## TECHNICAL SERVICE BULLETIN

# Triumph

BRAKE WARNING LIGHT RELAY

TR7

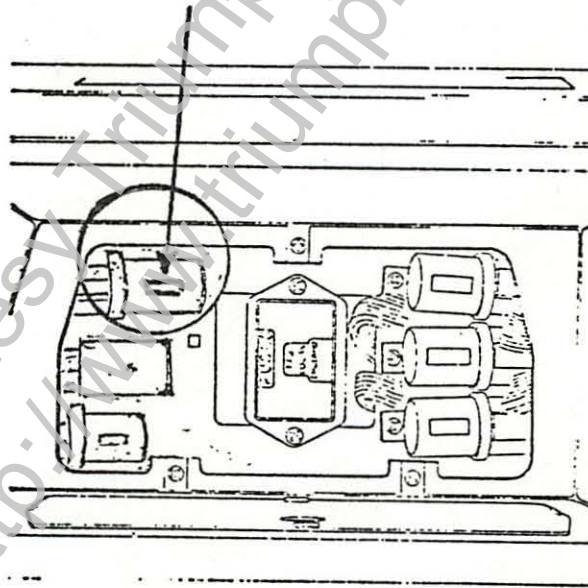
You may have noticed an additional relay which has been added to the TR7 (refer to diagram) on vehicles which have been arriving over the past few months, but which has not been depicted on the wiring diagram provided with the vehicle.

This relay, Lucas Part No. 33362, allows the driver to visually see that the brake warning lamp is functioning during the start mode (when starter motor is engaged).
